FINAL DRAINAGE REPORT

CROSSROADS MIXED USE
FILING NO. 2
EL PASO COUNTY, COLORADO

MARCH 2023

Project #18-004
PCD Filing No.: SF2238

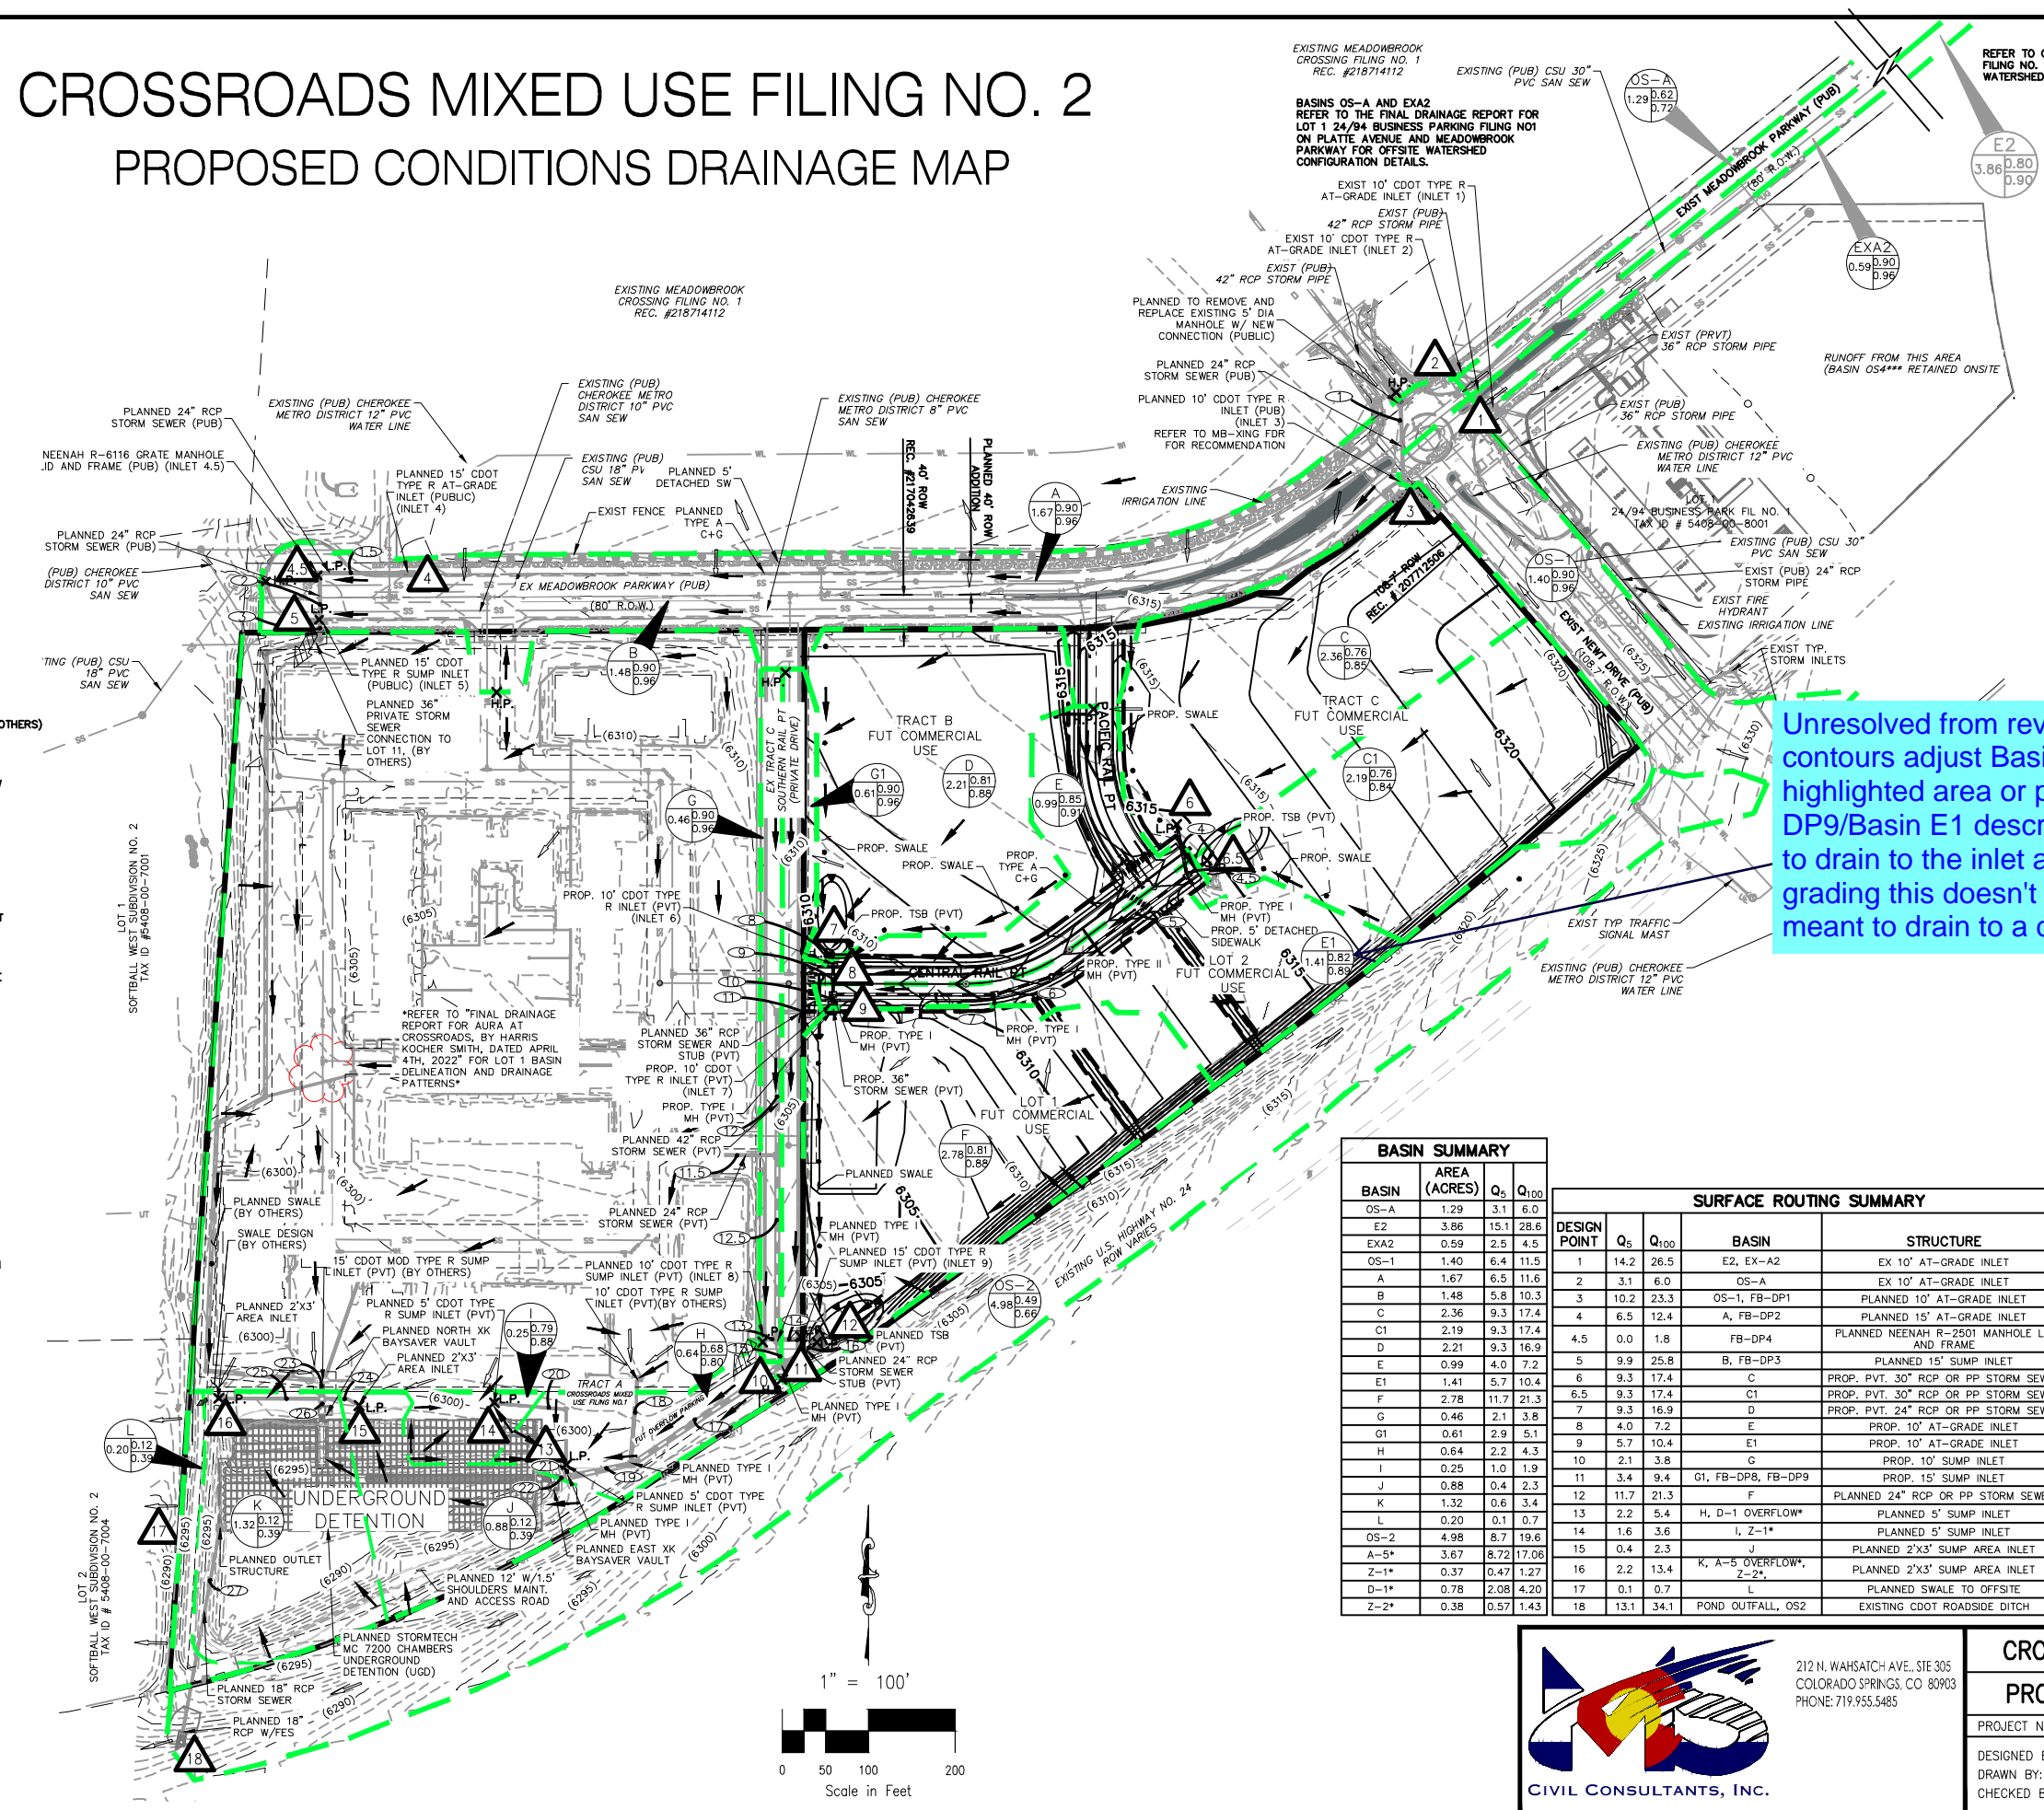
Unresolved from review 1. Based on the proposed contours adjust Basin F boundary to include the highlighted area or provide an explanation on the DP9/Basin E1 description on how this is supposed to drain to the inlet at DP9 (Based on the proposed grading this doesn't seem possible). Explain if it is meant to drain to a different design point.
